LaserBase MF5730
LaserBase MF5750
LaserBase MF5770

MFP-004
(SH-T01-0LD-10043-01)

Deletion of insulation sheet under the SCNT board assembly

P-1 SCNT BOARD ASSEMBLY
[1] Insulating sheet to be removed

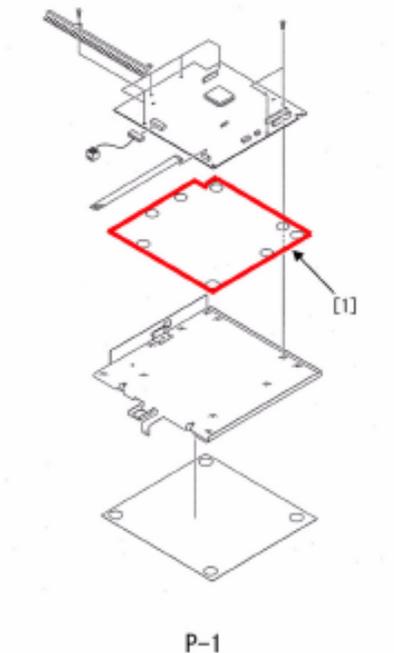
Due to the productivity, insulating sheet [1] under SCNT board assembly is removed.

There would be no problem even the insulating sheet is removed because the length of components under the SCNT board assembly, and a bend of SCNT board assembly and sheet metal have been already checked for the production.
